November 18, 2025

RE: Coyote Creek Agrivoltaic Ranch Project Final Environmental Impact Report  
 Sacramento County #PLN2021-00191 (SCH 2022010271)

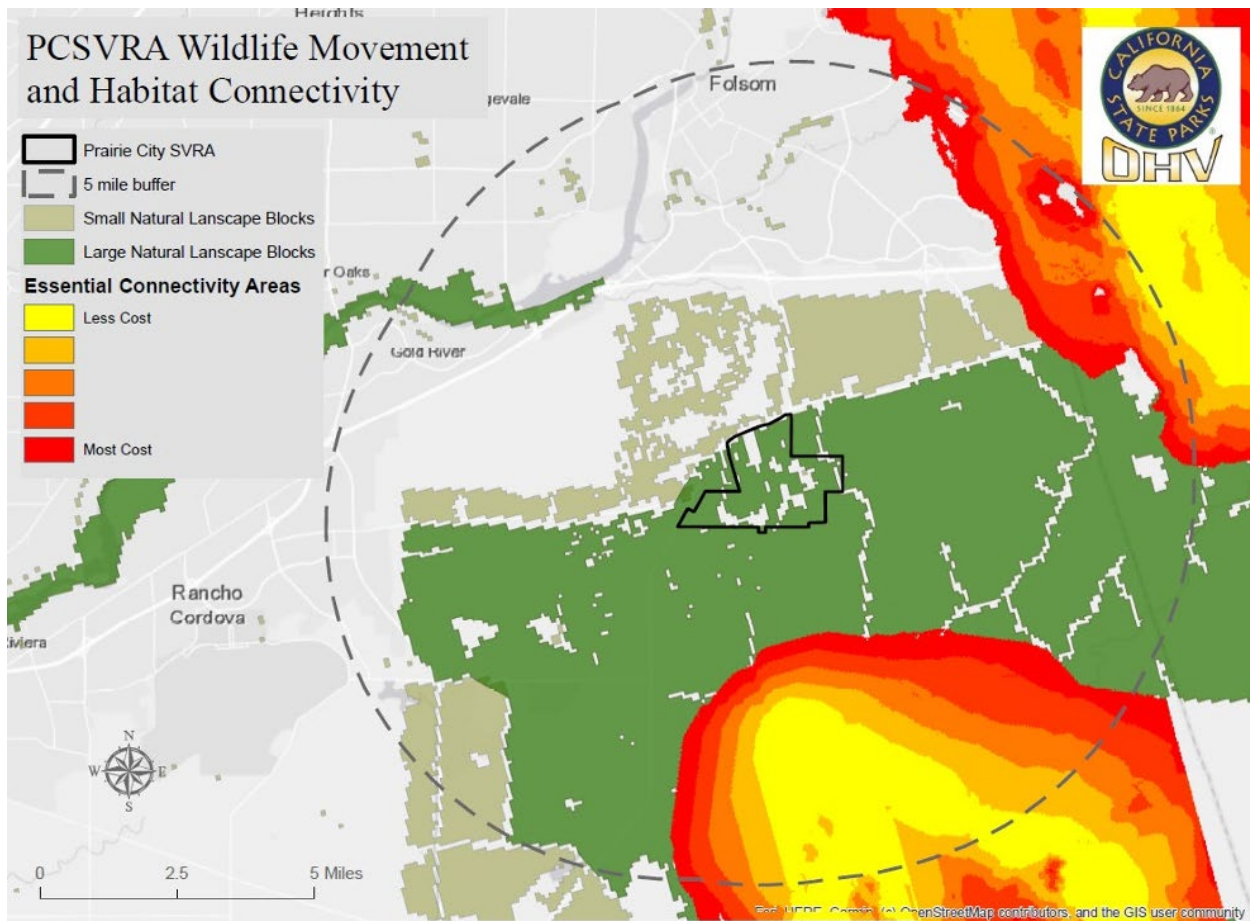
The FEIR claims that the preservation of 1,150 acres of oak woodland will help contribute to the goals of the South Sacramento Habitat Conservation Plan (SSHCP) to preserve 8,000 acres of oak woodland and savannah. These acres will be in narrow strips of land, surrounded by a massive industrial solar facility, and further fragmented by access roads running through otherwise undeveloped areas. The fragmentation caused by the development of the project site will greatly diminish the value of both the woodlands preserved on site and those surrounding the development area, equating to the loss of the entire 2,704-acre project site, and an additional, unanalyzed number of acres of adjacent lands in terms of habitat that would no longer serve as usable habitat for a wide range of species.

Blue oak's ability to disperse pollen to disjunct blocks of woodland would be impacted by fragmentation. Reduction of acorn production in this wind-pollinated species can occur when oaks are separated by 60 meters or more (Knapp, 2001). Many wildlife species avoid habitat

adjacent to development, making the preserved area essentially unusable for many species that rely on oak woodland habitat.

The California Department of Fish and Wildlife recommends that connectivity corridors be a minimum of 1500 feet wide (CDFW, 2024). The majority of the undeveloped lands proposed to provide connectivity are much narrower than 1,500', and all of these corridors have even narrower pinch points, as narrow as ~150 feet or less in some areas, with many areas ranging between 500 and 900 feet wide.

The FEIR has also mischaracterized the importance of the habitat connectivity corridors on the project site, describing them as "Natural Areas Small", however the map in the Prairie City State Vehicle Recreation Area (PCSVRA) Wildlife Habitat Protection Plan (WHPP) clearly shows that the project area is considered "Large Natural Landscape Blocks" and "Essential Connectivity Areas" by CDFW, indicating a much greater values to the Essential Habitat Connectivity network at the state-wide scale than is indicated in the FEIR.
